Figure correction in service manuals

The unbalanced connection diagram in the Test Procedures section of the Panaray (502) service manual, P/N 170310, and in the 402/802 II service manual, P/N 174785, is incorrect. **Figure 19 on page 33** of the 502 service manual and **Figure 24 on page 23** in the 402/802 II service manual should be changed as follows (only a partial figure is shown):

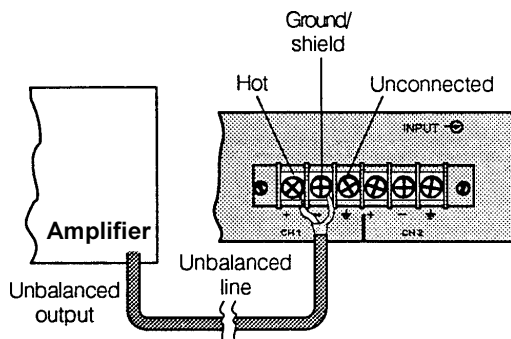
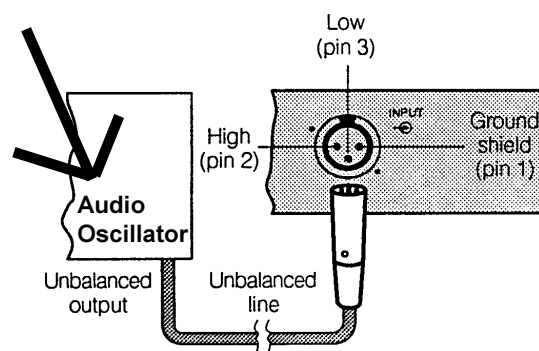
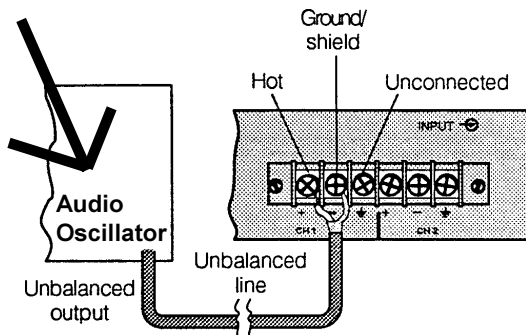
The input device was incorrectly identified as an amplifier. It should be a signal generator or audio oscillator.
